Economic and Social Council

World Forum for Harmonization of Vehicle Regulations

Proposal for Supplement 11 to the 03 series of amendments to UN Regulation No. 129 (Enhanced Child Restraint systems)

Submitted by the Working Party on Passive Safety*

Figure 1

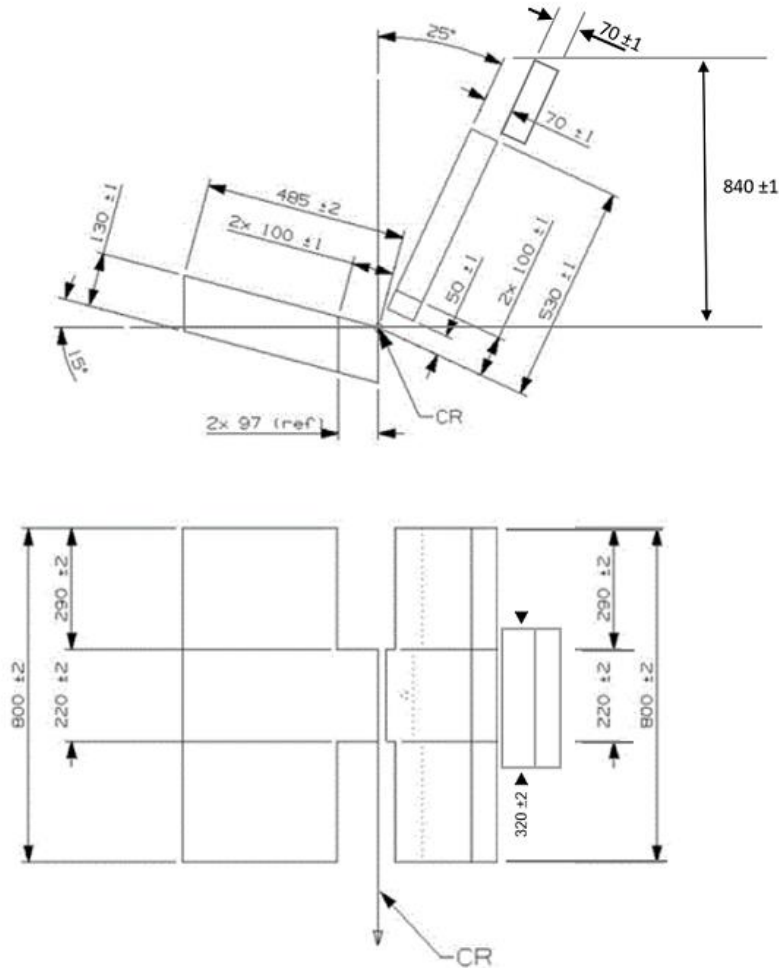
"3.4. Optional dummy protective device

An optional dummy protective device may be installed on the test bench for the dynamic frontal test of booster cushion when tested on the test bench described in this Annex.

The dummy protective device may be covered with the Polychloropren foam of the lateral impact door as defined in Appendix 3 of this Annex, or an alternative material, at the decision of the technical service.

The dimensions of the dummy protective device are given in Appendix 3 of this Annex.

The forward face of the dummy protective device shall be parallel with the back of the backrest. The design of the dummy protective device shall be such that it does not interfere with the manikin when positioned on the test bench. Furthermore, the dummy protective device shall not interfere with the dummy and/or the adult 3-point belt during the dynamic test until the maximum horizontal head excursion has been reached.

Insert new Annex 6 – Appendix 5, to read:

" Annex 6 - Appendix 5

Optional Dummy Protective Device
